Rezoning Application: PD 24-0579
Zoning Hearing Master Date: August 19, 2024
BOCC Hearing Meeting Date: October 8, 2024

The applicant seeks to rezone three parcels from RSC-9 (Residential Single-Family Conventional), AS-1 (Agricultural Single-Family) and ASC-1 (Agricultural - Single-Family Conventional) to PD 24-0579 (Planned Development) to permit a single-family residential development of up to 40 units with 40-foot-wide minimum lots.

8.0 PROPOSED SITE PLAN (FULL)

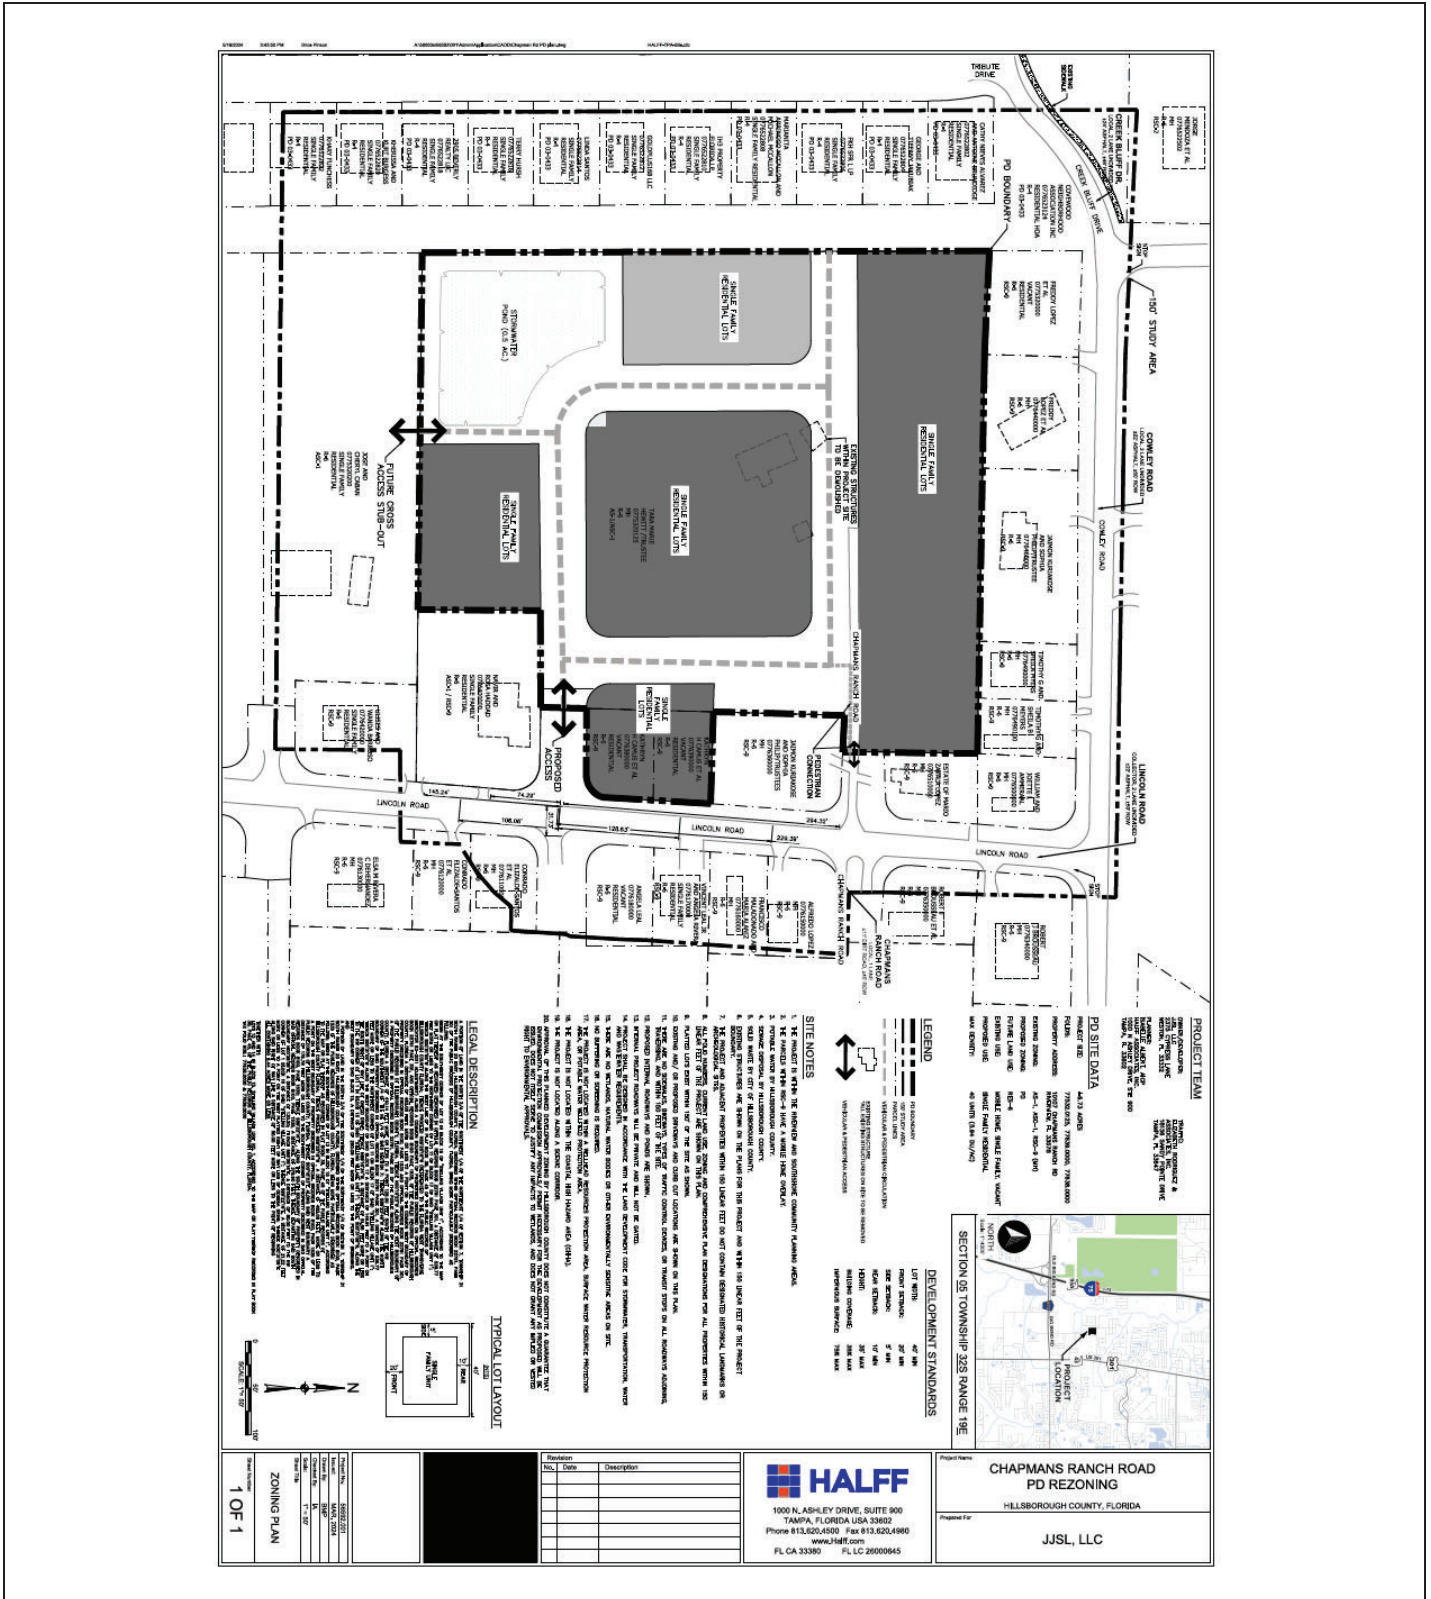
Prior to PD site plan certification, the developer shall revise the PD site plan to:

1. Add a note on the site plan that reads "Sidewalks to be provided per the LDC."
